Project	IEEE 802.16 Broadband Wireless Access Working Group < http://ieee802.org/16 >	
Title	Clarification on STC Data Mapping for Optional Zones	
Date Submitted	2005-03-16	
Source(s)	<p>Wonil Roh, JeongTae Oh, Kyunbyoung Ko, Chan-Byoung Chae, Hongsil Jeong, Sung-Ryul Yun, Seungjoo Maeng, Jaeho Jeon, Jaeyeol Kim, Jaehee Cho, Soonyoung Yoon, Yong Chang</p> <p>Samsung Electronics Co., Ltd.</p> <p>David Garrett, Erik Lindskog, Kamlesh Rath, Aditya Agrawal</p> <p>Beceem Communications, Inc.</p> <p>Wen Tong, Ming Jia, Hua Xu, Dongsheng Yu, Jianglei, Ma, Peiyong Zhu, Mo-Han Fong, Hang, Zhang and Brian Johnson</p> <p>Nortel Networks</p>	<p>wonil.roh@samsung.com</p> <p>Voice: +82-31-279-3868</p> <p>dgarrett@beceem.com</p> <p>wentong@nortelnetworks.com</p>
Re:		
Abstract	Clarification on STC data mapping for Optional Zones	
Purpose	Adoption of proposed changes into P802.16e	
Notice	<p>Crossed-out indicates deleted text, underlined blue indicates new text change to the Standard</p> <p>This document has been prepared to assist IEEE 802.16. It is offered as a basis for discussion and is not binding on the contributing individual(s) or organization(s). The material in this document is subject t

Figure 2511 — Uplink data mapping for 2-antenna SS with matrix A for the optional PUSC permutation

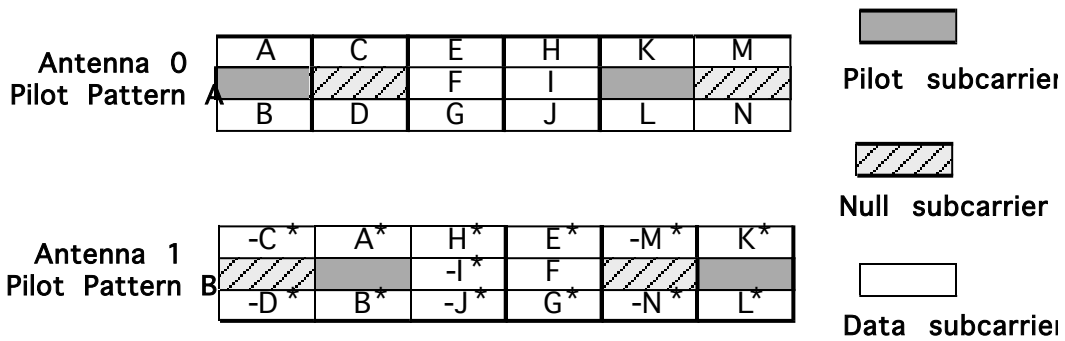
[Replace the text from line 42—49 on page 426 of [1] with the following:]

For the optional PUSC permutation with matrix A in 8.4.8.3.3, the data subchannels shall be allocated for two consecutive slots in time. As can be seen in Figure 251l, STC encoded data symbols shall be time mapped over two OFDMA symbols. The mapping starts at the lowest numbered subcarriers of lowest slot and continues in an ascending manner in subchannels first and then proceeds to the next two symbols in time.

For 2-antenna matrix B in the optional PUSC permutation, modulated data symbols shall be sequentially mapped for two transmit antennas along the subcarriers in the symbol. The mapping continues in an ascending manner in subchannels first and then proceeds to the next symbol in time.
